PCI-SIG ENGINEERING CHANGE NOTICE

TITLE:	MFVC
DATE:	December 19, 2003
AFFECTED DOCUMENT:	PCI Express Base Specification, Revision 1.0a
SPONSOR:	Joe Cowan; Hewlett-Packard Company

Figure 2-25: Virtual Channel Concept – Switch Internals (Upstream Flow)

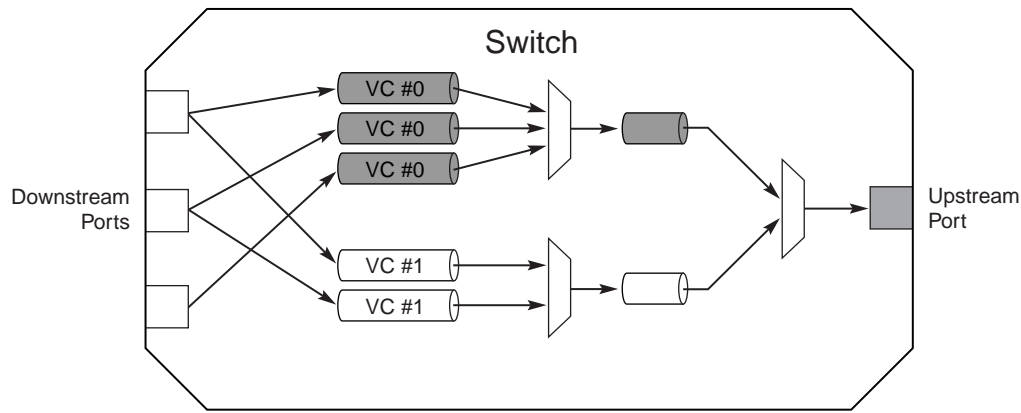
[A multi-function device may implement Virtual Channel resources similar to a subset of those in a switch, for the purpose of managing the QoS for upstream requests from the different functions to the device's Upstream Egress Port.](#)

Figure 6-9: Multi-function Arbitration Model

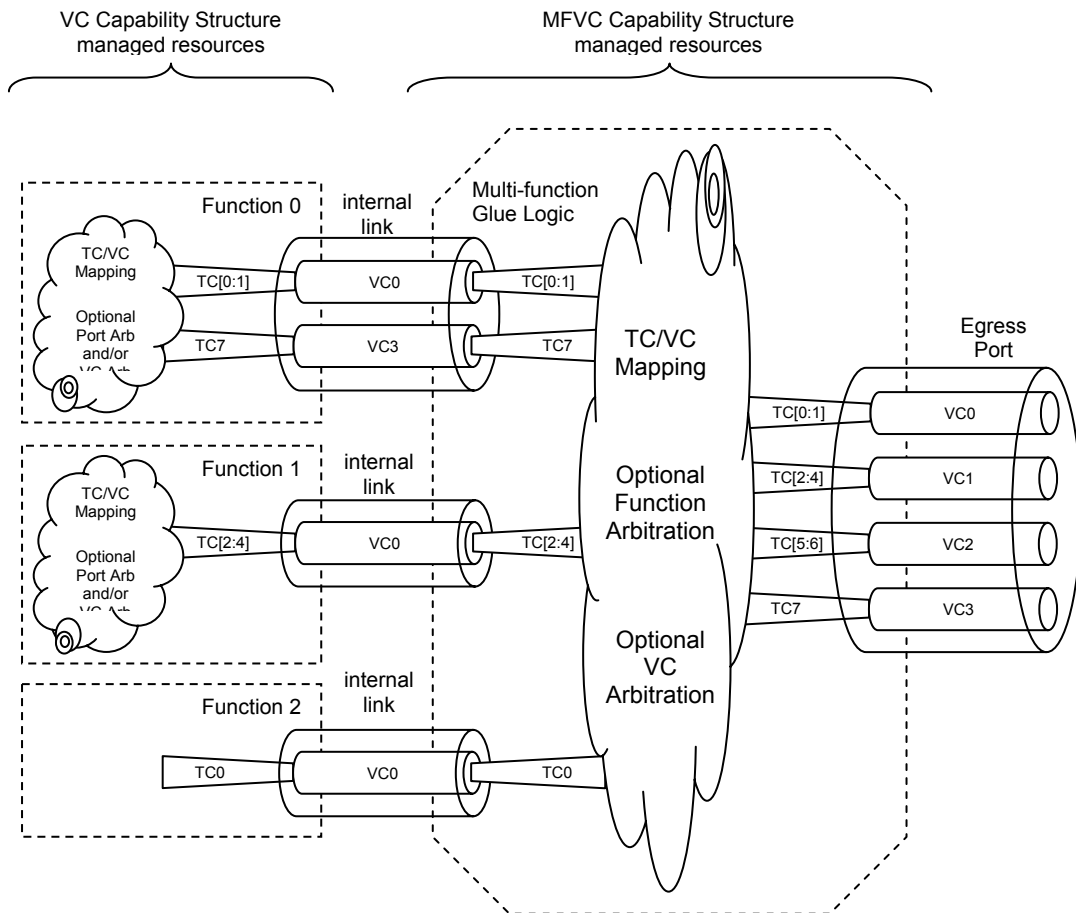
Add the following new section prior to Section 6.3.4 on page 283

Figure 6-9 shows a conceptual model of a multi-function device highlighting resources and associated functionality. Note that each function optionally contains a VC Capability structure, which if present manages TC/VC mapping, optional Port Arbitration, and optional VC arbitration, all within the function. The MFVC Capability structure manages TC/VC mapping, optional Function Arbitration, and optional VC Arbitration for the device's Upstream Egress Port. Together these resources enable enhanced QoS management for *upstream* requests. However, in contrast to a complete switch with devices on its downstream Ports, the multi-function device model does not support full QoS management for *peer-to-peer* requests between functions or for *downstream* requests.

Figure 7-44: VC Resource Capability Register

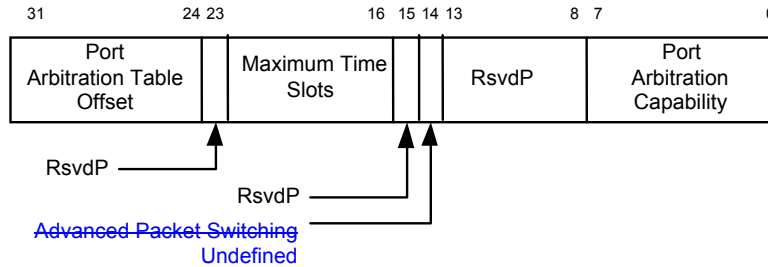
Section 7.11.6, p. 383, change text as shown:

Bit Location	Register Description	Attributes
14	<p>Advanced Packet Switching— Indicates the VC resource only supports transactions optimized for Advanced Packet Switching (AS). This field is valid for all PCI Express Ports and RCRB.</p> <p>When this field is set to 0, it indicates that the VC resource is capable of supporting all transactions defined by this specification (including AS transport packets).</p> <p>When this field is set to 1, it indicates that the VC resource only supports transactions optimized for Advanced Packet Switching, and, therefore, must not be used for non-AS packet traffic.</p> <p><u>Undefined – The value read from this bit is undefined. In previous versions of this specification, this bit was used to indicate Advanced Packet Switching. System software must ignore the value read from this bit.</u></p>	RO

Figure 7-56: PCI Express MFVC Capability Structure

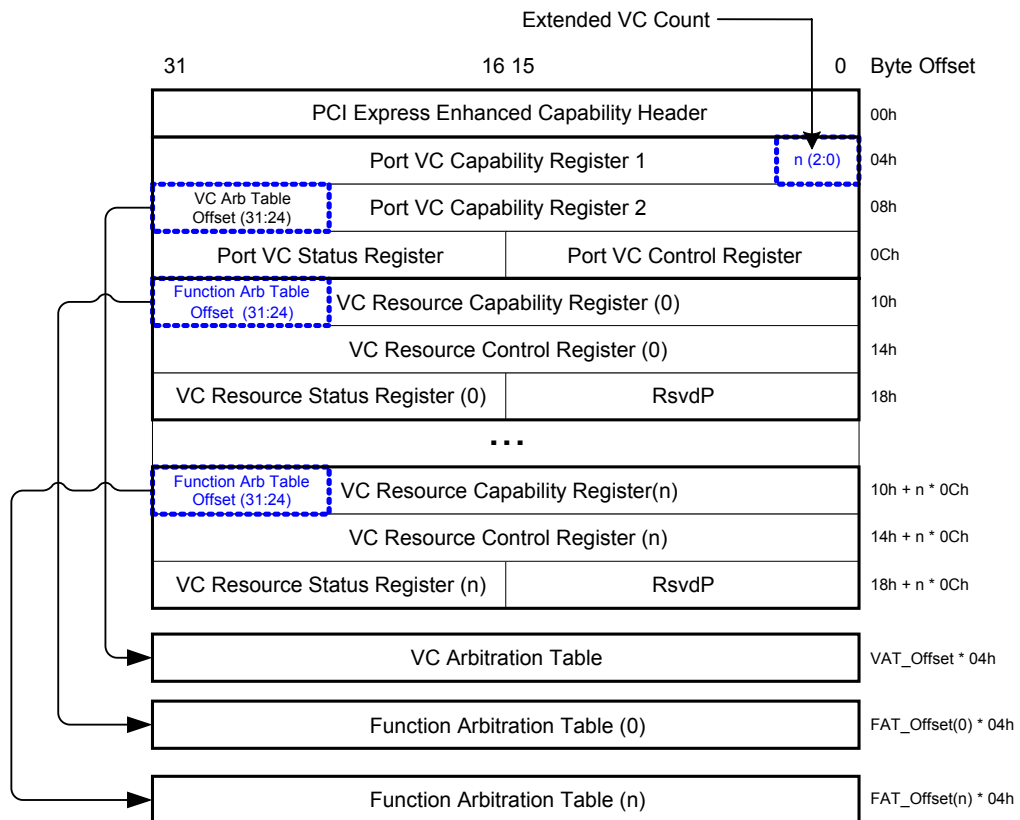
Add the following new section at the end of Chapter 7 after page 398 (Note that Section 7.14 is used by another errata):

7.15. Multi-Function Virtual Channel Capability
